ATTACHMENT A

Responses to the NRC Request for Additional Information

U.S. Department of Energy
National Nuclear Security Administration
Docket No. 71-9355, TAC No. L24741
Certificate of Compliance No. 71-9355
Model No. 435-B

Figure 1.1-3 – 435-B Package With Shielded Device

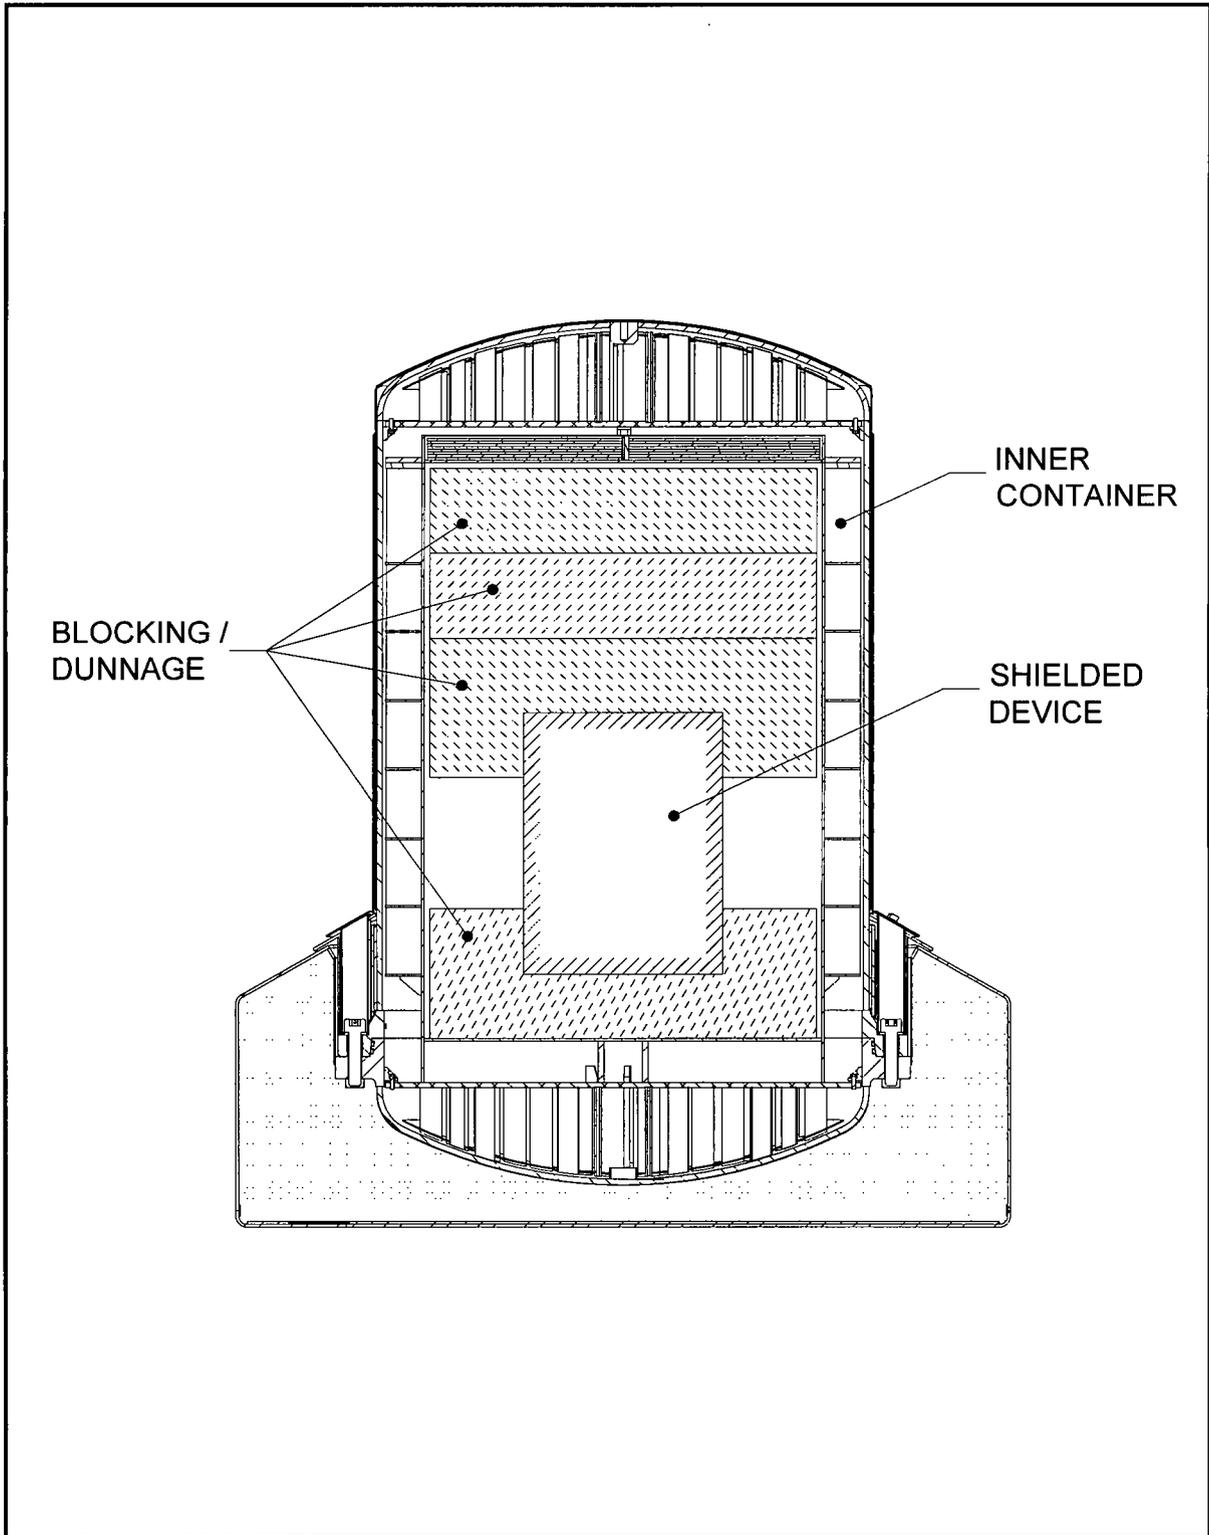
RAI - 3 Explain and discuss Figure 1.1-3, “435-B Package with Shielded Device,” on page 1.1-4 of the SAR. Include a description of the shielded device.

Based on Figure 1.1-3, describe the following in detail:

Response: Figure 1.1-3 is meant to represent all of the shielded devices inside the inner container inside the 435-B packaging. The figure represents schematically the generalized arrangement of blocking/dunnage and the shielded device contents. Since several different shielded devices may be shipped in the package and different blocking/dunnage arrangements may be used, the figure must be schematic. The shielded devices are described in detail in Section 1.2.2.2 and Table 1.2-2.
